Glen Canyon Institute
3090 East 3300 South, Suite 400
Salt Lake City, UT 84109

December 20th, 2022

Comments on Supplemental Environmental Impact Statement for December 2007 Record of Decision Entitled Colorado River Interim Guidelines for Lower Basin Shortages and Coordinated Operations For Lake Powell and Lake Mead Sent via email to CRinterimops@usbr.gov.

Reclamation 2007 Interim Guidelines SEIS Project Manager
Upper Colorado Basin Region
125 South State Street, Suite 8100
Salt Lake City, Utah 84138

Graph from Bureau of Reclamation presentation December 2nd, 2022

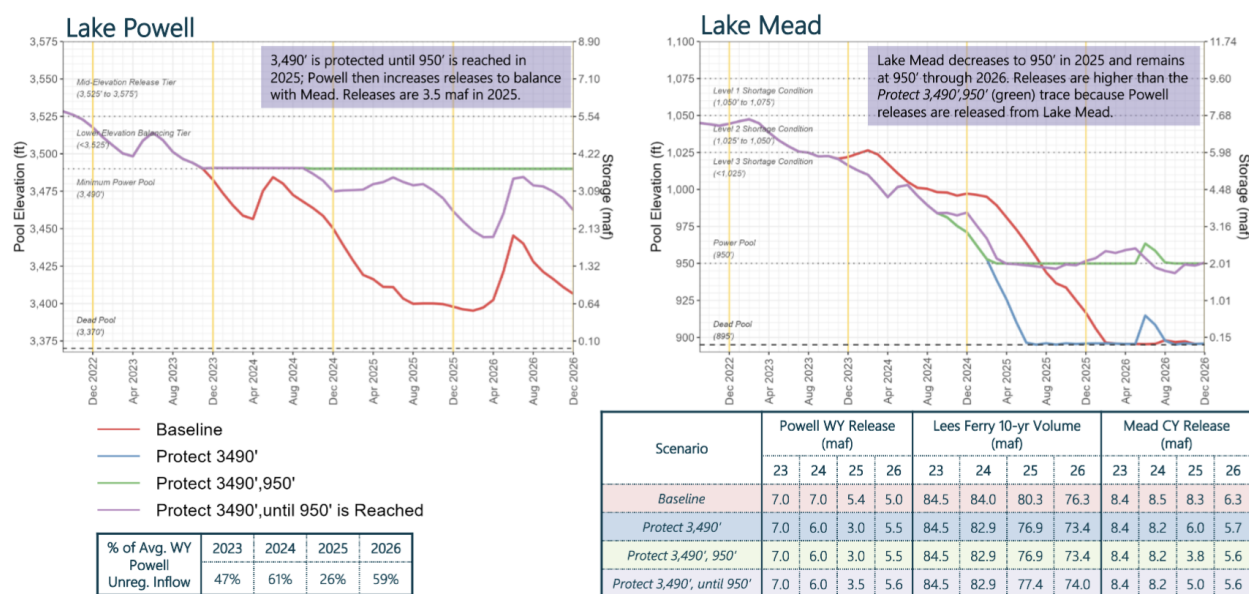
In a webinar for this SEIS, Reclamation released its own analysis, resulting in similar projections to reservoir levels in GCI's analysis. By modeling reservoir elevations at Lake Powell and Lake Mead under hydrologies similar to those in the early 2000's, it's clear that both reservoirs could quickly fall below near pool and near dead pool levels. The scenarios presented by BOR entertain different actions aimed at protecting Lake Powell versus Lake Mead. In the webinar, it was expressed by Reclamation officials that there is great concern of Glen Canyon Dam operating solely by its river outlet works (ROW's), and that there may be a need to withhold releases downstream to "prop up" Powell and delay it from relying on it's ROW's.

Given the probability, even with efforts to “save Powell first”, that Lake Powell could drop below minimum power pool and Glen Canyon Dam will operate solely on its ROW's⁵, and given that this SEIS will likely shape future management strategies, including the post-2026 guidelines, there is a significant need to consider physical modifications to Glen Canyon Dam.

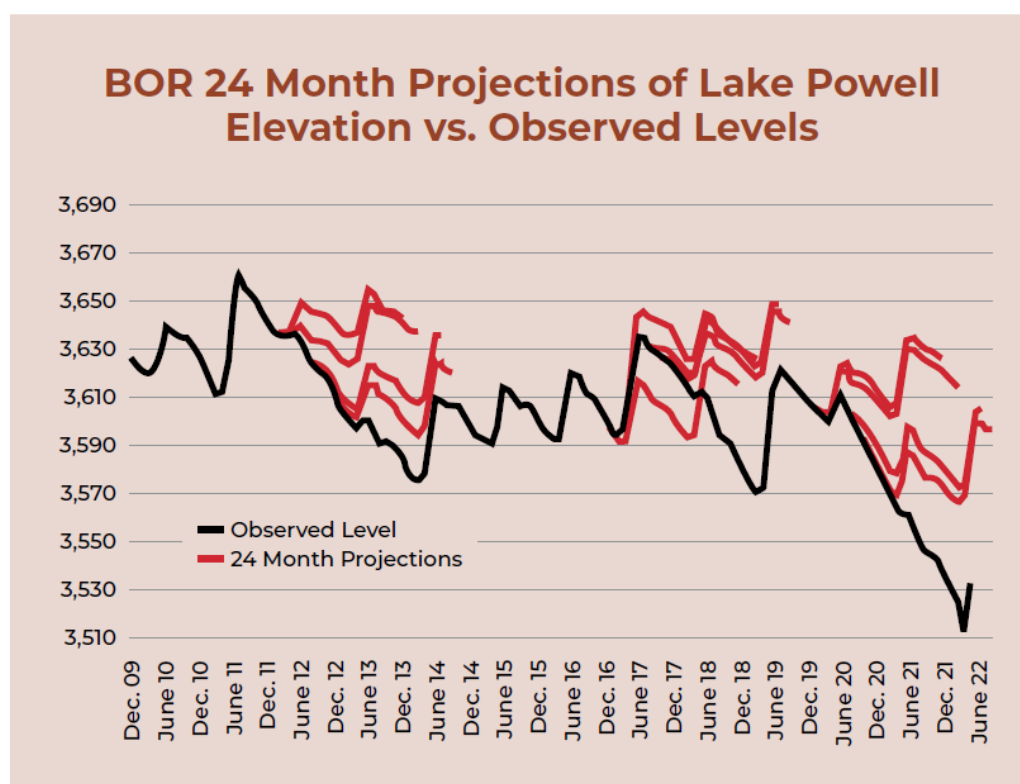
The above figure, showing levels of Lake Powell between December 2009 and June 2022, demonstrates how far Lake Powell water levels have declined over time, as shown in black. The red lines are Bureau of Reclamation 24 month “most probable” forecasts which demonstrate a bias to overestimating the amount of water that will be in Lake Powell. Reproduced from White Paper #7, Figure 7.

The use of the 30-year statistical modeling is standard for water managers, but in the Colorado River Basin it has been proven to be outdated and leaves water managers and stakeholders unprepared. Reclamation should incorporate a wider set of data, like those used by the Futures of the Colorado Group¹¹ and Western Water Assessment¹², in 24-month and 60-month projections.

Figure from What will it take to stabilize the Colorado River?, *Science Magazine*

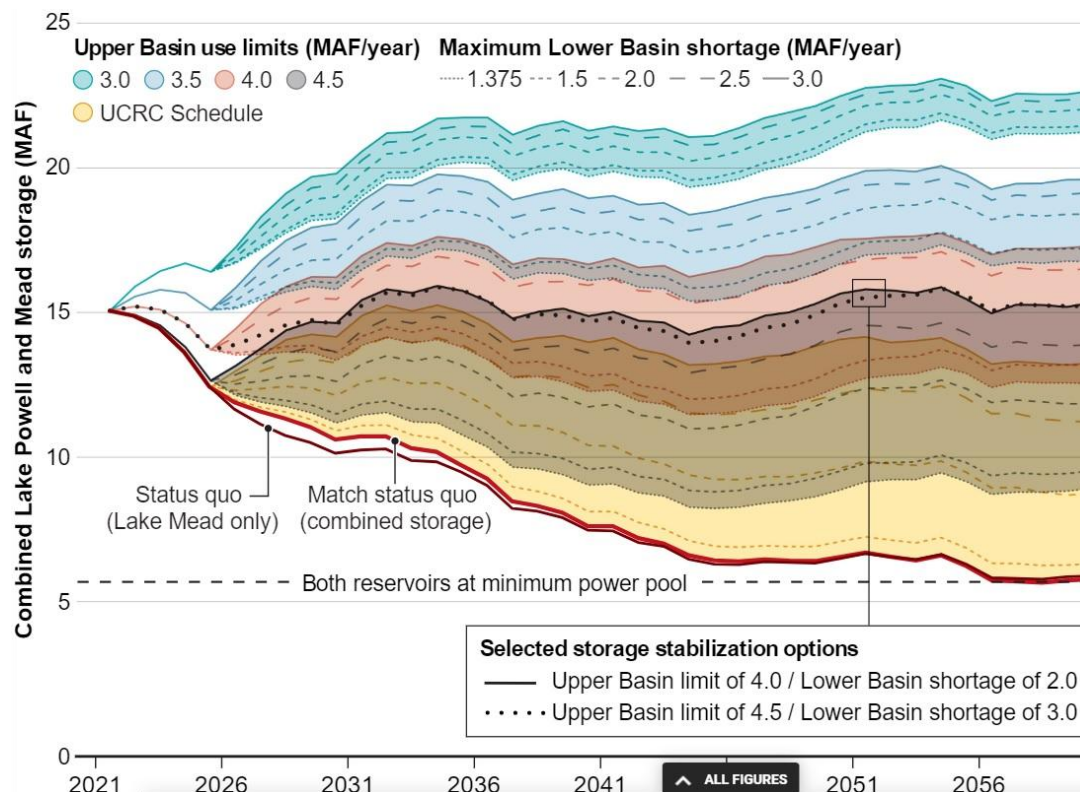
The figure above, from Wheeler et al. in *Science*¹⁷, shows an array of future possibilities of combined storage totals between Powell and Mead, based on existing shortage curtailment schedules and different Upper Basin depletion scenarios. The figure shows that with climate impacts not getting worse, and significant reductions implemented from the Upper and Lower Basin, system storage will still only stabilize, not increase. It's also worth noting that this graph assumes a starting point of 15 million acre feet of live storage between Powell and Mead. As of

December 2022, the reservoirs' combined storage is 12.86 million acre feet¹⁸¹⁹, lower by more than 2 million acre feet.

Based on the Wheeler et al. projections, if Basin states cannot come to an agreement on widespread reductions of consumptive use and/or climate continues to reduce runoff, storage at Powell and Mead will continue to drop precipitously. As stated earlier, climate science suggests runoff will get worse, the fundamental issue of whether the Basin states can agree to widespread cuts remains unclear²⁰.

Projected elevation of Lake Powell reservoir levels into the future from March 2023 forward, given observed historical hydrologic periods of both 2000 – 2004 and 2017 – 2021.

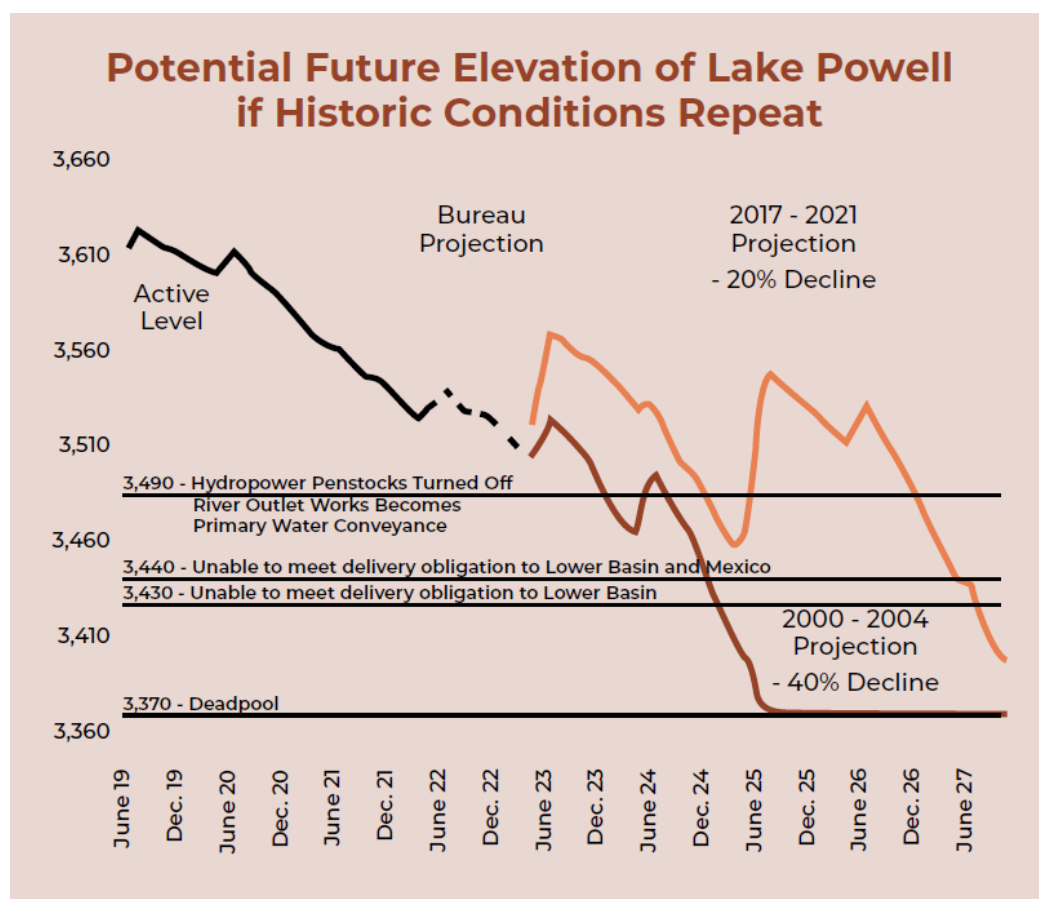
When forecasted into the future using these two historic periods, Lake Powell quickly drops to levels well below the critical elevation thresholds of 3,440 and 3,430 feet above sea level. This exercise is not meant to be a prediction that Lake Powell will follow either of these paths over this time frame. Projecting Lake Powell’s actual water levels over the next five years with a high degree of certainty is very difficult, especially without incorporating potential future curtailments. This exercise merely demonstrates it is plausible that Powell could drop to critical elevation thresholds in the near future, and reflects similar outcomes to the charts shared by Reclamation at its December SEIS webinar.

As demonstrated by the charts above and Reclamation’s own charts presented at its SEIS webinars, there is a significant enough likelihood of Powell dropping below power pool and near dead pool that Reclamation should have every tool available to operate the system in such scenarios. Currently those tools are unavailable, because of plumbing limitations at Glen Canyon Dam, and the lack of modeling done around alternative scenarios where Lake Powell is drawn down to low levels or run-of-river level.
